# **RENESAS TECHNICAL UPDATE**

Product Category	MPU/MCU	Document No.	TN-RX*-A169A/E	Rev.	1.00	
Title	Note regarding increase of supply current in consumption mode for RX231 Group	low power	Information Category	Technical Notification		
Applicable Product	RX231 Group Chip Version A (R5F5231xAxxx) Chip Version B (R5F5231xBxxx)	Lot No. All	Reference Document	RX230 Group, RX231 Manual: Hardware Rev.1.10 (R01UH0496		ser's

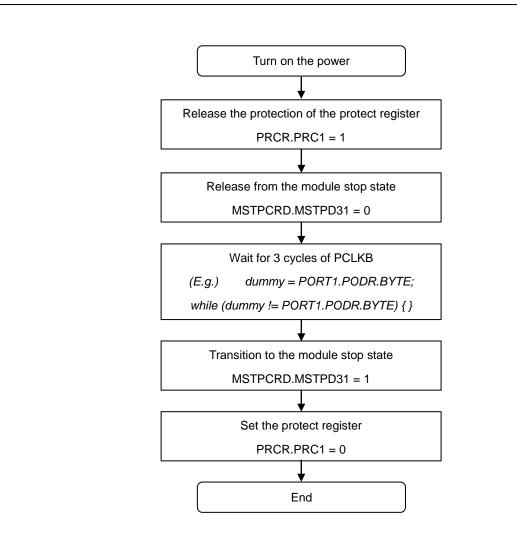
A circuit which is not used in user mode may not be reset and may keep operating in an unstable state because clocks are not being supplied during an MCU reset. Therefore, supply current may increase to a value greater than that stated in the user's manual by up to  $600 \,\mu\text{A}$  when the MCU transitions to low-speed operating mode or software standby mode.

Perform the following procedure at the initial setting for the MCU to initialize the unused circuit mentioned above.
